Sent: 2/2/2026 10:09:19 AM
From: Derek Porcella <derek.porcella@flocksafety.com>
To: Sing, Soratha@DOT
Cc: "Bobby" , "Wendy Stratton" , "Hayley"
Bcc:
Importance: Normal
Subject: Re: 423899 - Benicia PD - Encroachment Permit Application; 0424-NSV-0053
Attachments [image001.png](#) , [image002.png](#) , [image003.png](#)
: [image004.jpg](#)
, [31C3EAEA3E6E4956BE733A9B2F800ECC.png](#)
, [image005.png](#)

Subject: RE: 423899 - Benicia PD - Encroachment Permit Application; 0424-NSV-0053

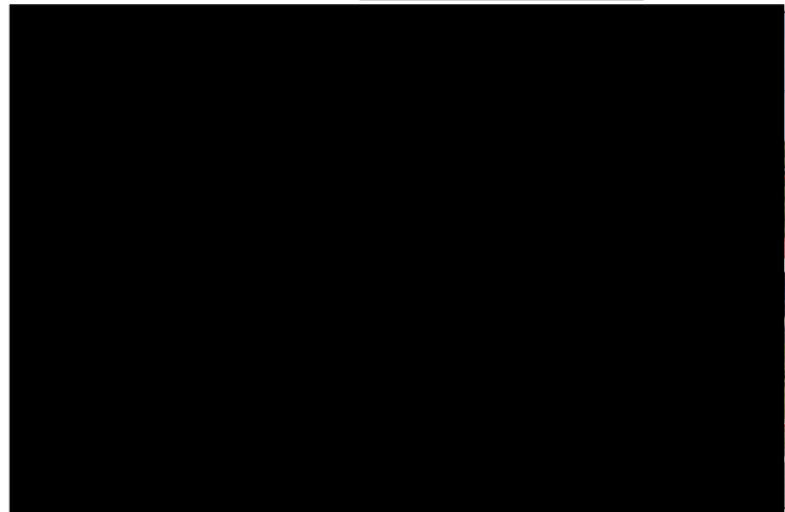
- Please provide As-Built of the existing light pole (see image below).
- Please provide calculations showing the proposal would not overstress the pole base, base plate, and anchor bolts. Also, bear in mind that add'l items have been added to the existing pole and shall be accounted for in the calcs.
- Calculations shall conform to AASHTO's Std Specs for Structural Supports for Hwy Signs, Luminaires, and Traffic Signals, Sixth Edition 2013 (aka: LTS-6).
